V8 XJ Series

TECHNICAL BULLETIN

Draft Welt Loose –
Front Door Opening –
Install Edge Finisher

MODEL 1998-2002 MY
V8 XJ Series
VIN 812256-F47334

ILLUSTRATION 1

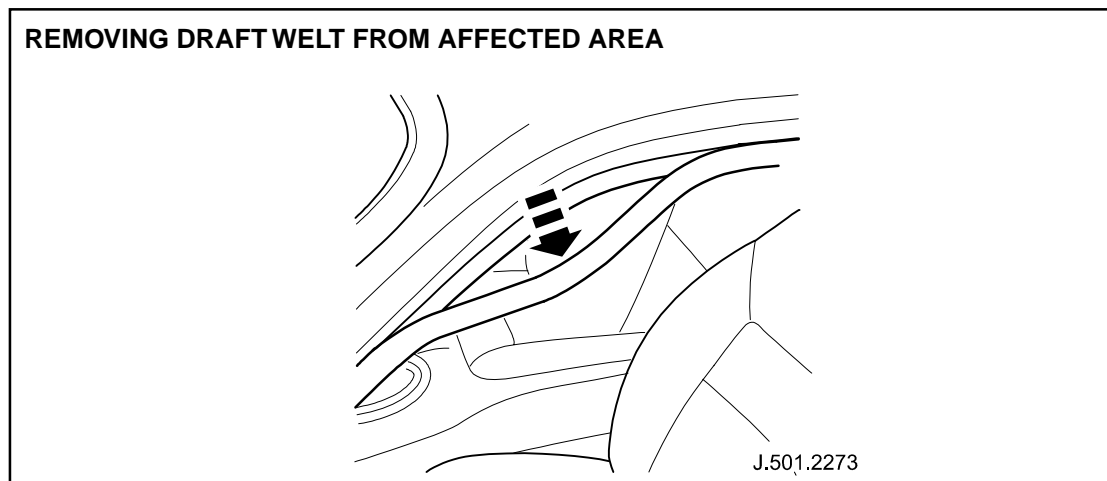
1. Displace draft welt from top of front door aperture A-post body flange (Illustration 1).

ILLUSTRATION 2

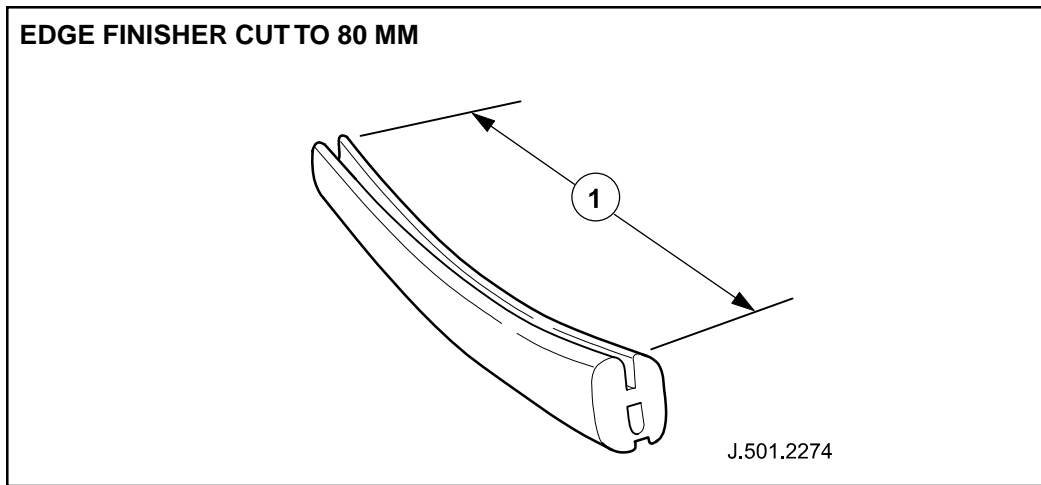
2. Using suitable snips, cut two pieces of edge finisher (DAC 4027/16) to 80 mm length (item 1, Illustration 2).

ILLUSTRATION 3

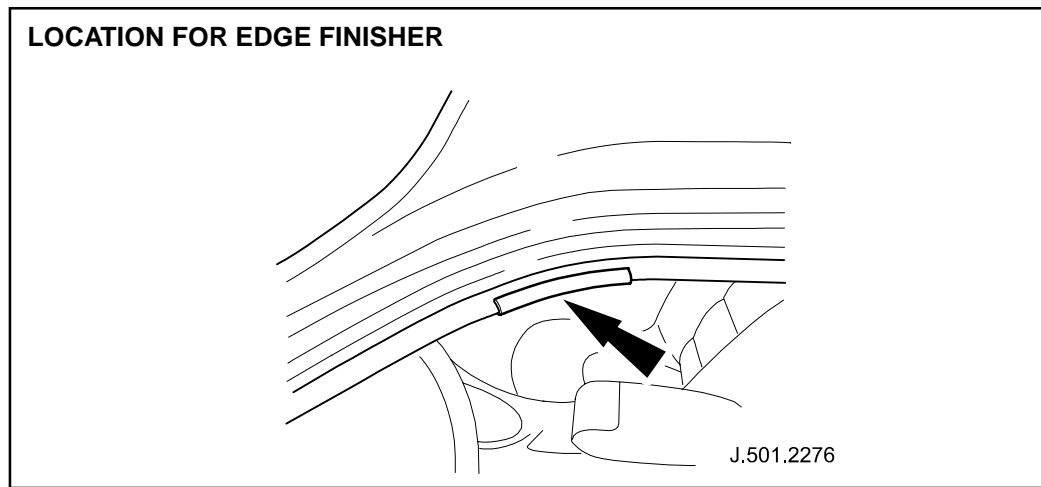
3. Install and seat sized length of edge finisher to top of front door aperture A-post body flange (Illustration 3).

Note: Be careful not to spread out edge finisher.

ILLUSTRATION 4

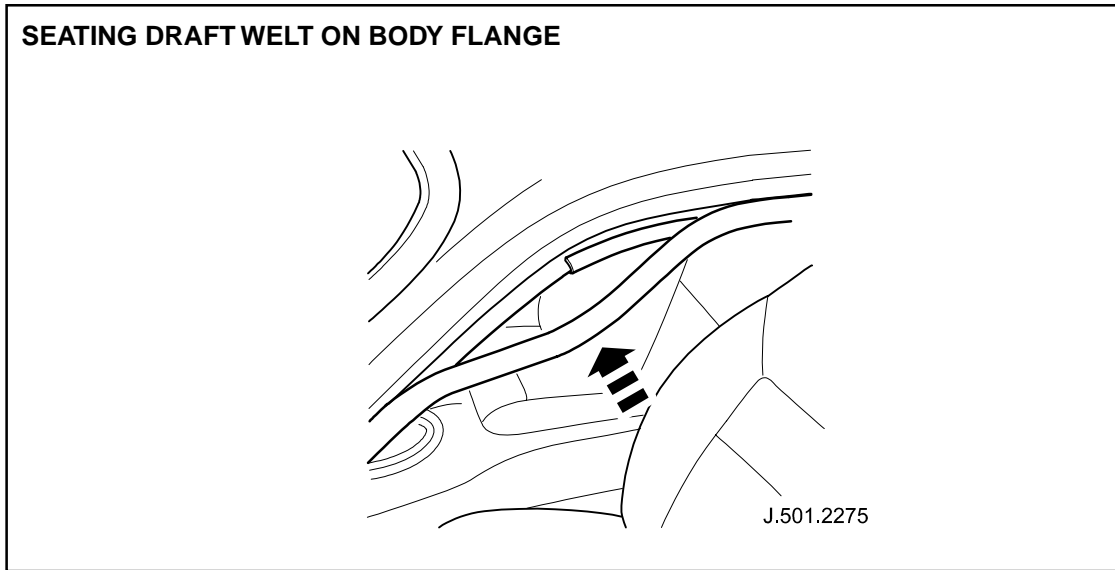
5. Install and seat draft welt to front door aperture a-post body flange (Illustration 4).
6. Repeat steps 2 to 5 on the opposite side of the vehicle.
